NONCONFORMANCE - REPORT LOG & STATUS BOOK

1. PROJECT NO. 7220

PROJECT NAME ¹ Midland 1 & 2 JOB NO. ¹ 7220 PAGE ⁸ 44

A(629)B
10/22/76

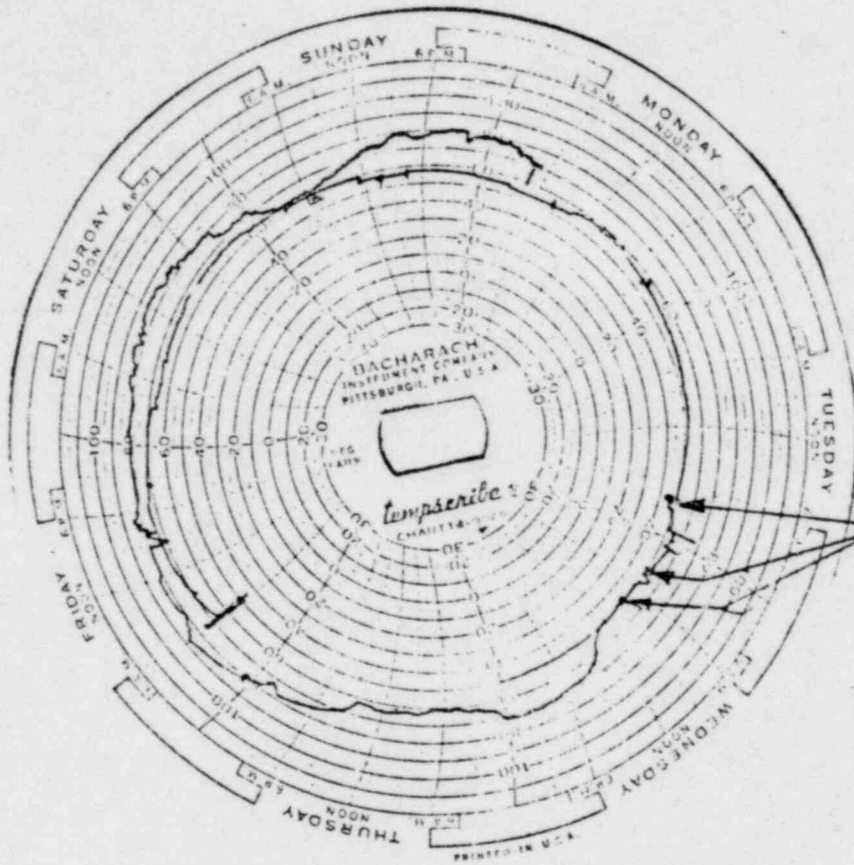
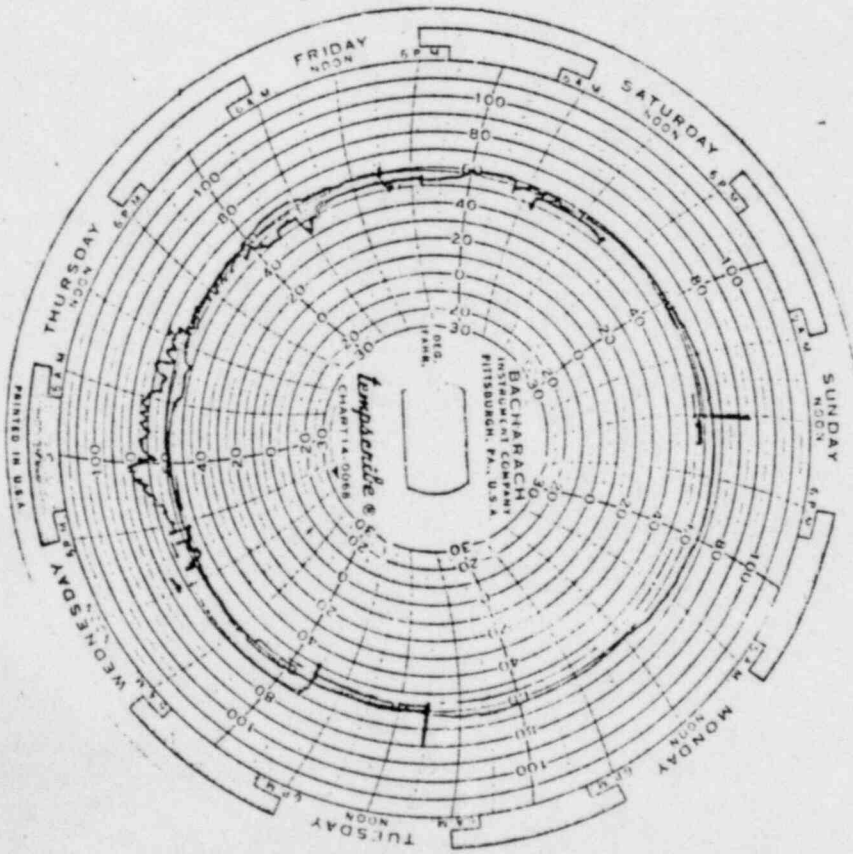
1. Project Name Midland Nuclear Plant		Job No. 07220		19. No. 580	20. Page 1 of 1			
2. Unit(s) Common	3. Drawing/Part No. N/A	Rev N/A	4. Item Description Concrete Curing		5. Item Location Aux. Bldg. E1. 014'-0" H to K Line 6.6 to 7.2			
6. P.O. Or Spec No. N/A	7. Serial No. N/A	8. Replacement Part P/N N/A REV _____	SER NO. _____	9. Source Construction	10. Contractor/Supplier N/A			
11. Inspection Criteria <input type="checkbox"/> DWG <input checked="" type="checkbox"/> SPEC <input type="checkbox"/> OTHER		IR NO. C-1.40-77 NO. 7220-C-231	12. ASME AUTHORIZED INSPECTION REQ'D <input type="checkbox"/> YES <input checked="" type="checkbox"/> NO	13. SKETCH ATTACHED <input type="checkbox"/> YES <input checked="" type="checkbox"/> NO	14. Discovered During <input type="checkbox"/> REC.G <input checked="" type="checkbox"/> CONST <input type="checkbox"/> TEST			
16. Nonconforming Condition: Spec. 7220-C-231, Rev. 11, Paragraph 13.2.4 states that during curing a concrete surface temp. of 50°F must be maintained. However the temp. of the floor topping of pour A(614)h-2 dropped to 43° for 2 hrs. and 47° for 1 hour on 10/22/76. Nonconformance noted during Q. C. surveillance. Hold for final Engineering disposition. One hold tag applied.					15. Equip Furnished By <input type="checkbox"/> CLIENT <input type="checkbox"/> ENG <input type="checkbox"/> FLD			
					24. Disposition Concurrence			
					<table border="1"> <tr> <td>REWORK</td> <td>REJECT</td> <td>REPAIR</td> <td>USE AS IS</td> </tr> <tr> <td></td> <td></td> <td></td> <td><input checked="" type="checkbox"/></td> </tr> </table>	REWORK	REJECT	REPAIR
REWORK	REJECT	REPAIR	USE AS IS					
			<input checked="" type="checkbox"/>					
17. Reported By <i>Ames Series</i>		Date 10/28/76	18. Validated By <i>R. Kennedy</i>		Date 10-28-76			
21. Routing <input checked="" type="checkbox"/> TO FIELD ENGINEERING <input type="checkbox"/> TO OTHERS (SPECIFY)					25. Disposition Results			
22. <input type="checkbox"/> Field Engineering Disposition <input checked="" type="checkbox"/> FIELD ENGINEERING RECOMMENDED DISPOSITION TO PROJECT ENGINEERING								
Use as is. This topping was done with D-1 grout. Curing was for 7 days and subsequently extended for 1 additional day. <i>R. Kennedy 11/2/76</i> <i>Ames Series 11/11/76</i>								
23. Project Engineering Disposition								
The lower concrete curing temperature will tend to reduce shrinkage, setting rate, and water demands, while increasing durability and required curing time. Engineering concurs with the field recommended disposition to "use as is" because (1) The minimum concrete surface temperature was 43°F for 2 hours and freezing did not occur. (2) The cure for the subject concrete pour was extended one full day.								
					26. QC Acceptance <i>Ames Series</i>			
					QC ENGINEER 12/13/76			
					DATE			
					AUTHORIZED INSPECTOR <i>Ames Series</i>			
					DATE 12-2-76

TEMP BELOW 50°F

23. Project Engineering Disposition The lower concrete curing temperature will tend to reduce shrinkage, setting rate, and water demand, while increasing durability and required curing time. Engineering concurs with the Field recommended disposition to "use as is" because (1) The minimum concrete surface temperature was 48°F for a total estimated period of 1 1/2 hour and freezing did not occur. (2) The cure for the subject concrete pour was extended one full day.		26. QC Acceptance <i>A. Jones</i>		Date 12/13/76

fig. 295

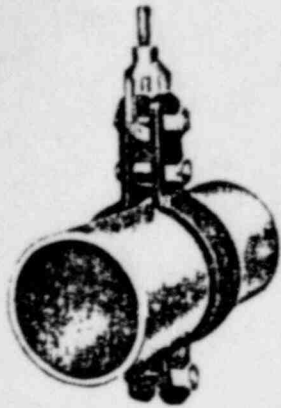
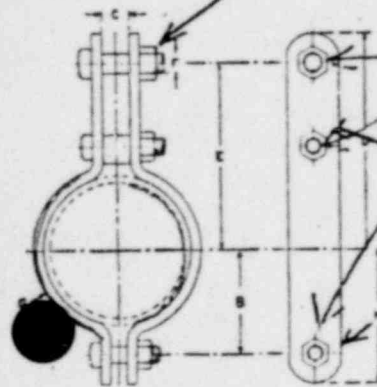
16. Nonconforming Condition: Figure 295 pipe clamps are specified by the following ITT Grinnell hanger sketches required to complete pipe hanger installations shown on drawing GH 613 sh 1, Rev. 0. sketch 2-613-1-1 Rev. 1, sketch 2-613-1-22 Rev. 1, sketch 2-613-1-23 Rev. 2, sketch 2-613-1-21 Rev. 1			24. Disposition Concurrence N.A. REWORK REJECT REPAIR USE AS IS PMS [Signature] 12/1/76 PROJECT-FIELD ENGINEER DATE PROJECT ENGINEER DATE PROJECT CONSTR QC ENGINEER DATE [Signature] 12-3-76 AUTHORIZED INSPECTOR DATE			
(continued on next page)

*"F" BOLT DIAMETER
NOT SPECIFIED
AS TYPICAL
3 PLACES*

*BOLT NUT
MATERIALS
NOT SPECIFIED*

21. Routing <input checked="" type="checkbox"/> TO FIELD ENGINEERING <input type="checkbox"/> TO OTHERS (SPECIFY)		22. <input checked="" type="checkbox"/> Field Engineering Disposition <input type="checkbox"/> FIELD ENGINEERING RECOMMENDED DISPOSITION TO PROJECT ENGINEERING				
The bolt diameters for the 2 1/2 inch, 3 inch, and 6 inch ITT Grinnell figure 295 pipe clamps specified on hanger sketches 2-613-1-1, 2-613-1-21, and 2-613-1-23 respectively are as shown on the attached mailgram (Page 7 of 7). All bolts for the 4 inch figure 295 pipe clamps specified on hanger sketch 2-613-1-22 are of uniform diameter (i.e. dimension "F" shown on page PH-14 of ITT Grinnell catalog PH-76-see page 3, Attached) con't on page 2			23. Project Engineering Disposition Chuck Great 12-6-76
